HANFORD 100-BC REACTOR AREA CLEANUP

Will DOE Soil Cleanup Protect Groundwater?
Will DOE Restore Groundwater to Its Highest Beneficial Use?

John R. Brodeur, P.E., L.E.G.
Energy Sciences & Engineering
Kennewick, Wash.

September 2005

(Fig.1)

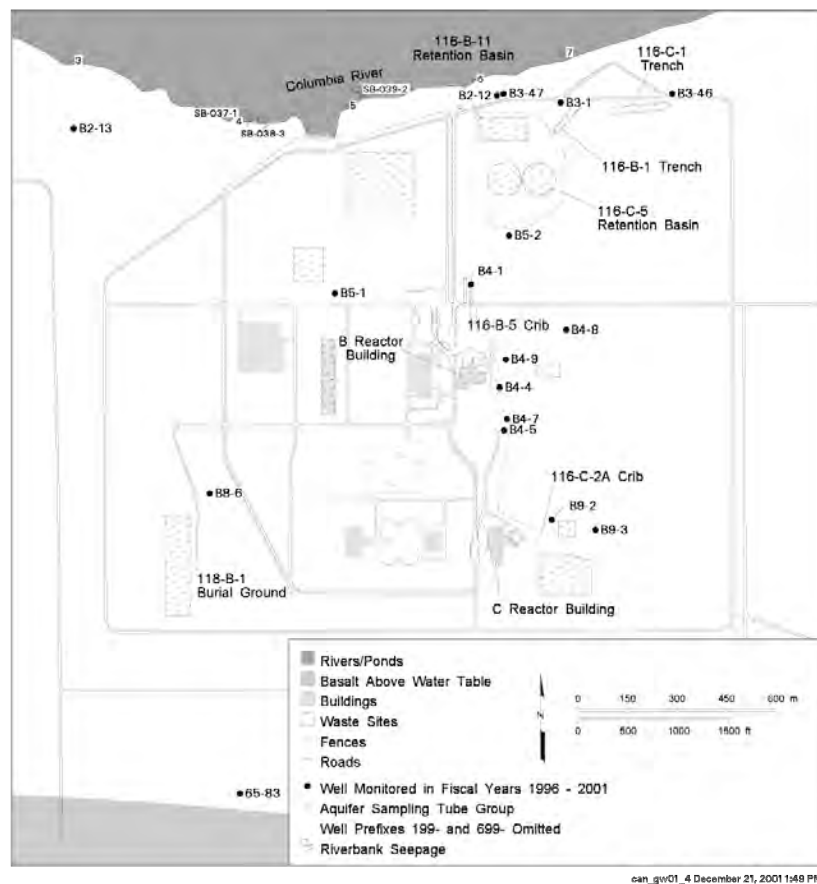
The 116-B-1 and 116-C-1 trenches (Figure 1) were used as liquid-effluent disposal sites whenever there was a fuel element failure in the reactor. When it was apparent that a fuel cladding

Trench 116-B-1 is approximately 200 feet long, 30 feet wide and 15 feet deep and located 400 feet east of the 116-B-11 retention basin (Figure 1). It was used from 1948 until 1955 whenever fuel-cladding failures occurred. After 1955, degradation of the concrete in the B-11 retention basin no longer allowed separation of effluent batches and cladding-failure effluent was sent to the Columbia River instead of to the trench. The B-1 trench received approximately 16M gal of cooling effluent that contained fission products, activation products, transuranics and sodium dichromate (2mg/L).

(Figure 2)

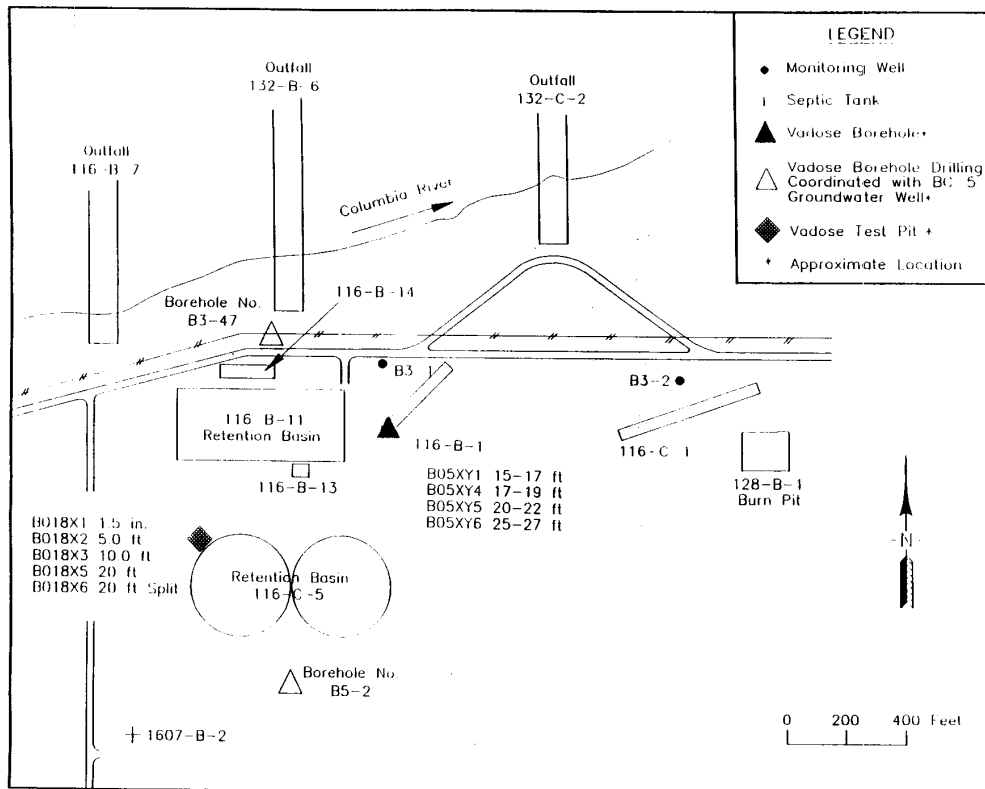
One borehole was drilled through the 100-BC-1 trench as a part of the LFI for the 100-BC-1 OU (Figure 2).. Four samples were taken from depths of 16, 18, 21 and 26 feet. Radionuclide and metals assay data is summarized in Tables 2 and 3. Data shows that from the trench bottom, radionuclide concentrations decrease with depth, to the maximum sampling depth of 26 feet. Unlike D&R, Sr-90 is not an exception to this general trend for the depth range of the data.

(Figure 3)

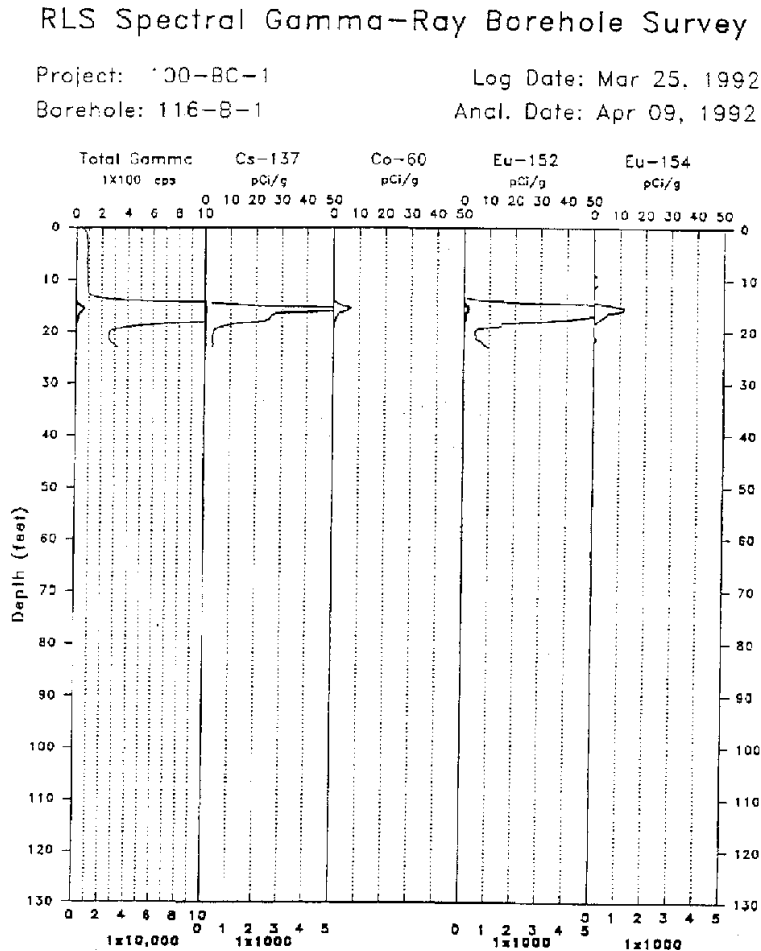
Spectral gamma-ray logging of the LFI borehole (Figure 3) shows the highest Cs, Co and Eu concentrations near the 15 feet depth, which is the bottom of the trench structure. Spectral gamma logs also show the depth extent of cesium and europium has not been reached at 23 feet, the maximum depth of gamma log data.

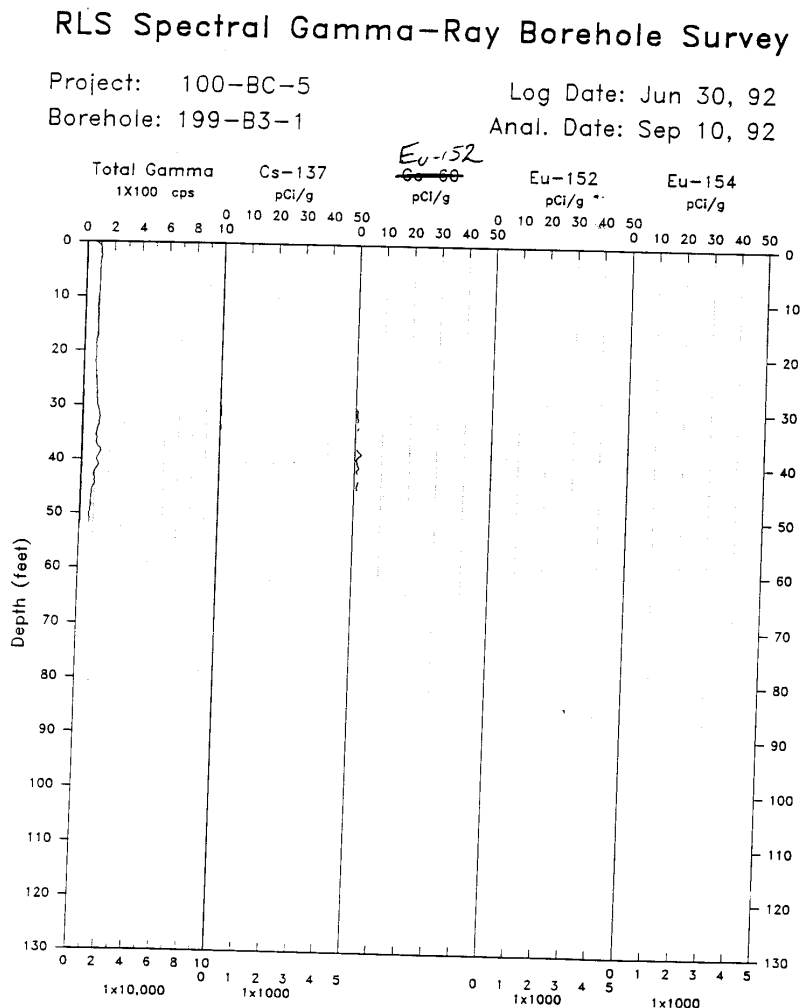
An exceptionally poor plot of some of the spectral gamma ray log data from this groundwater well (Figure 4) shows a region between approximately 30 and 50 feet at which low concentrations of Cs-137 and Eu-152 are found. The concentration representation on the plot is not visible, but it is there. The cesium in particular, is a low-mobility radionuclide and poses a relatively low risk to human health and safety. This low-concentration cesium is interpreted to be the result of unsaturated moisture flow and the migration of contamination from the 116-B-1 trench to the location of this well, approximately 150 feet away. Alternately, it is the same from the C-11 retention basin. Qualified plots of the potassium, uranium and thorium concentrations in this borehole

might be useful for correlating lithology with contamination distribution, but they are not provided.

Figure 9. 116-C-1 Test Pit Data - ¹³⁷Cs, ¹⁵²Eu, ⁶³Ni

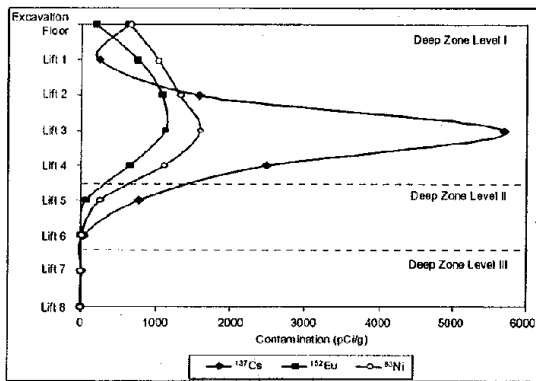
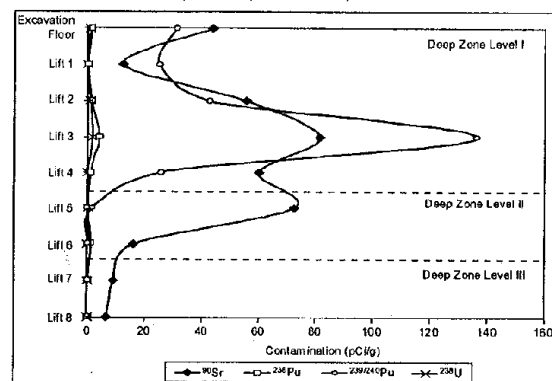
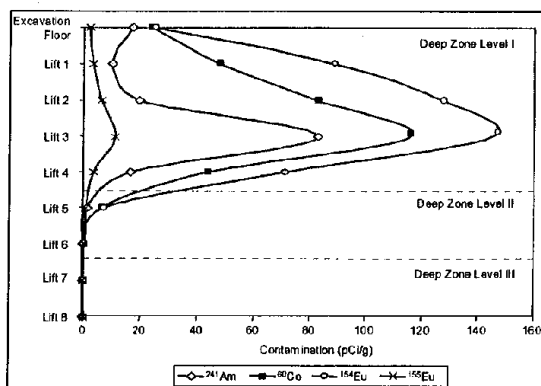
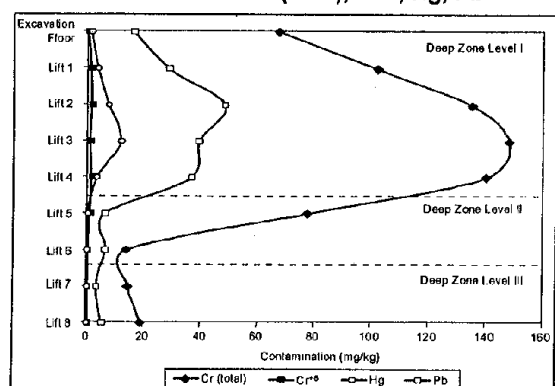
After the site was remediated by excavating to a depth of 16 feet, a test pit was dug to provide data on the deeper vadose-zone sediment as a part of the remediation-verification process. This test pit was located near the inlet to the trench and was excavated to groundwater. The test-pit excavation occurred in eight lifts of three-foot depth each, from the bottom of the excavation to the groundwater table (eight lifts x three feet/lift = 24 feet). Soil samples were taken from four quadrants of the test pit and composited together to create one sample for analysis per lift or depth. Samples were analyzed for a select list of radionuclides (Figure 6). Notably absent from these plots is an assay for Tc-99, which was apparently dropped as a contaminant of concern in the 1998 version of the sampling and analysis plan (DOE 2001); the justification for this is not provided in the document.

The test-pit data generally confirms the results of D&R (Table 6a); the bulk of the contamination is at or below a depth of approximately 20 feet, which is below the depth of remediation excavation. It is clear from the test-pit data that the limited sampling in D&R missed the bulk of the contamination, as D&R appropriately concluded. The test-pit data provides the only data on the

deeper vadose-zone contamination, with the exception of a single data point from the sample taken from a groundwater monitoring well 150 feet away.

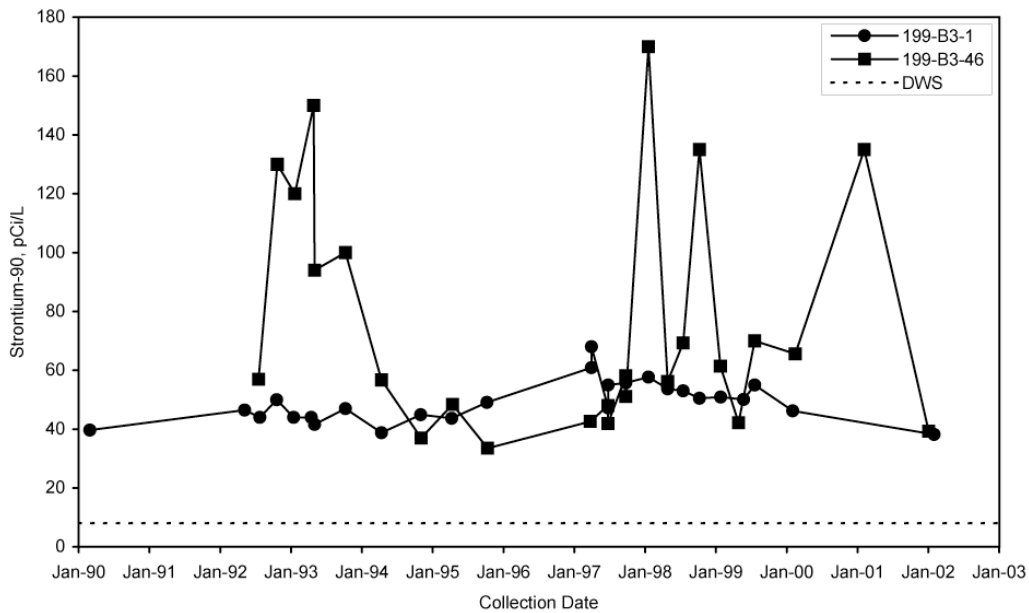
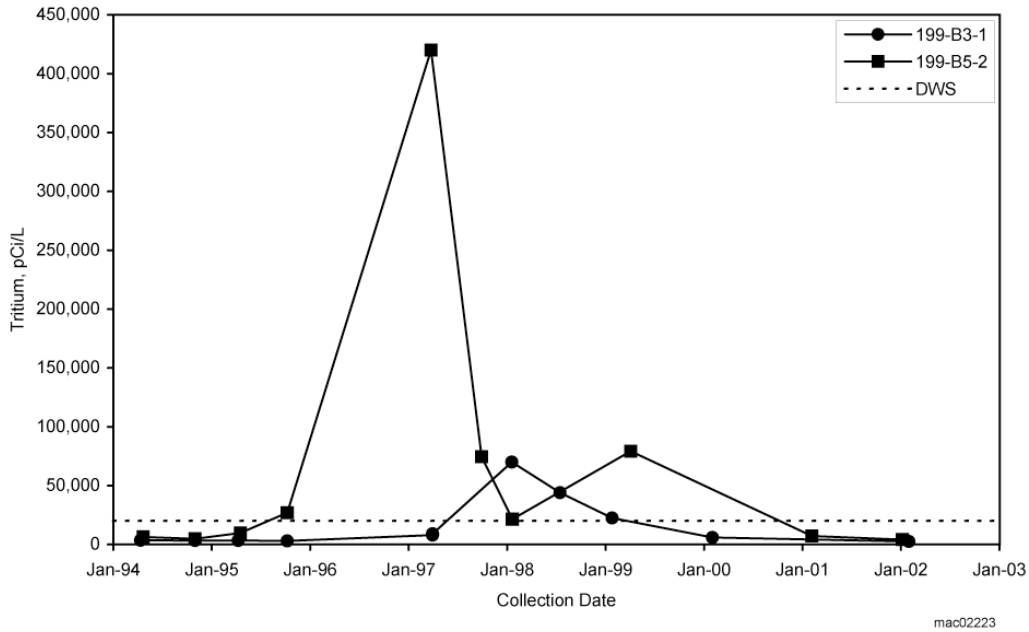
Sr-90 data from the 2002 groundwater-monitoring report shows a rather large but erratic increase in groundwater concentration just after the site was remediated. The contamination levels increased from approximately 50 pCi/L (MCL = 8 pCi/L) to more than 160 pCi/L. This is similar to other groundwater-monitoring data in the BC Area in the 1998 time frame. However, the previous increase in this particular well in 1993, and the erratic nature of the 1998 increase, do not provide conclusive evidence of a correlation between increased infiltration due to site remediation and the increase in groundwater contamination. At the same time, we must criticize the lack of any assessment of the temporal changes in groundwater contamination in general, and the lack of any assessments of this Sr-90 data specifically. We believe this data shows evidence of infiltration-induced groundwater contamination. This conclusion is supported by Sr-90 and tritium-monitoring data from other BC Area groundwater wells.

contamination is determined and considered in a more accurate calculation of groundwater contamination levels? Does the remediation still meet the RAG? Looking at the results of the RESRAD modeling exercise, we doubt that it will. And, if one looks at the groundwater monitoring data for 199-B3-46 (Figure 5b), it is clear what the data suggests.
